Smokers' Outpost- NEW Design

New & Improved Standard Smokers' Outpost

Design Changes:

New Design Changes

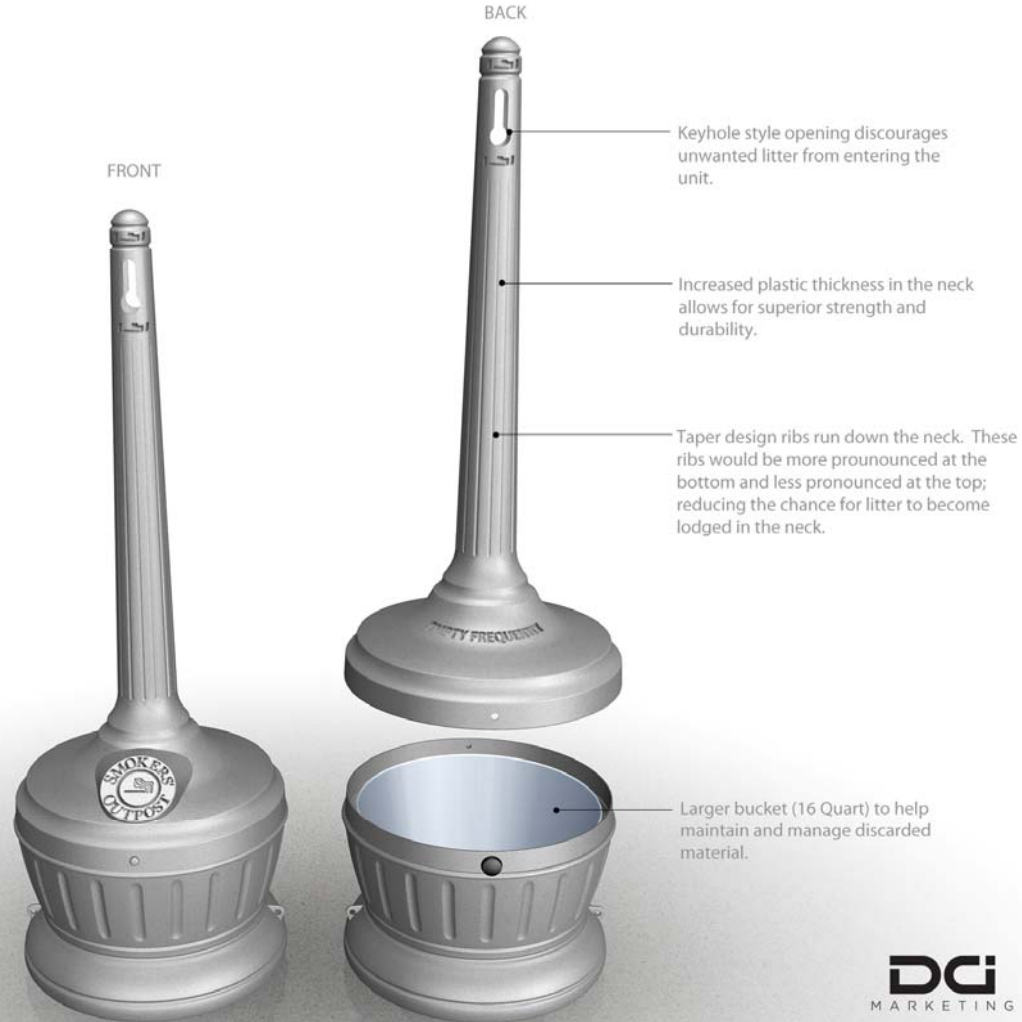
Large "Empty Frequently" is embossed onto the molded part and makes it easy to see from a distance.

The large ridge between the top and bottom reduces oxygen from entering the unit.

- Keyhole style opening will discourag the placement of unwanted litter!
- Increased wall thickness in the neck area for superior strength and durability
- Improved neck design helps prevent unwanted litter from becoming lodged in the neck
- Larger pail to manage discarded material.
- Tighter fit in seam to reduce oxygen flow into base
- “Empty Frequently” is embossed on unit to encourage proper maintenance
